UNITED STATES PATENT AND TRADEMARK OFFICE

APPLICATION NO.	FILING DATE	FIRST NAMED INVENTOR	ATTORNEY DOCKET NO.	CONFIRMATION N
10/783,119	02/20/2004	Bradley Cooper		1183
7590	10/01/2004			
Bradley Cooper 7323 Emerald Glen Dr. Sugar Land, TX 77479			EXAMINER HOEY, ALISSA L	
			ART UNIT 3765	PAPER NUMBER

Office Action Summary	Application No. 10/783,119	Applicant(s) COOPER, BRADLEY	
	Examiner Alissa L. Hoey	Art Unit 3765

DETAILED ACTION

Fig. 1

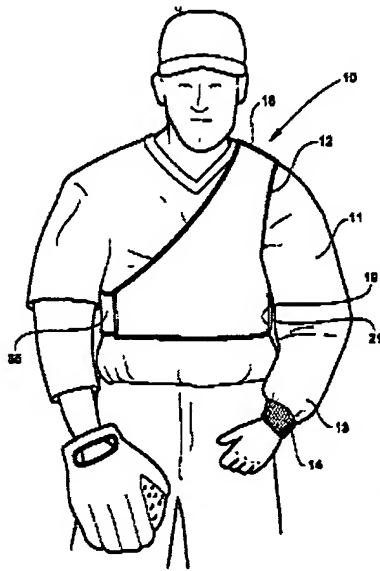
In regard to claims 1-3, Dellinger provides a warm-up jacket (10) for a pitcher having a portion that surrounds the upper extremity below the wearer's arm (11). A portion of the jacket (10) extending over the front chest quadrant (12), shoulders (18) and at least a portion of a first arm (11). A second arm and associated upper extremity and shoulder region are not covered by the jacket (figure 1). The arm covered (11) by the jacket (10) is the arm used in pitching and a fastener element (40, 41) permitting the region portion of the jacket surrounding the chest to be separated.

In regard to claims 7-9, Dellinger provides a jacket (10) having a portion covering at least one arm (11) and associated regions of the abdomen (22, 28), an aperture (23, 24) in the jacket (10) exposing a second arm and associated regions of the abdomen. A lower portion (28) for securing the jacket to the abdomen including a fastener (40, 41). The jacket (10) permits one arm (11) and associated regions to retain heat (column 1, lines 65-67).
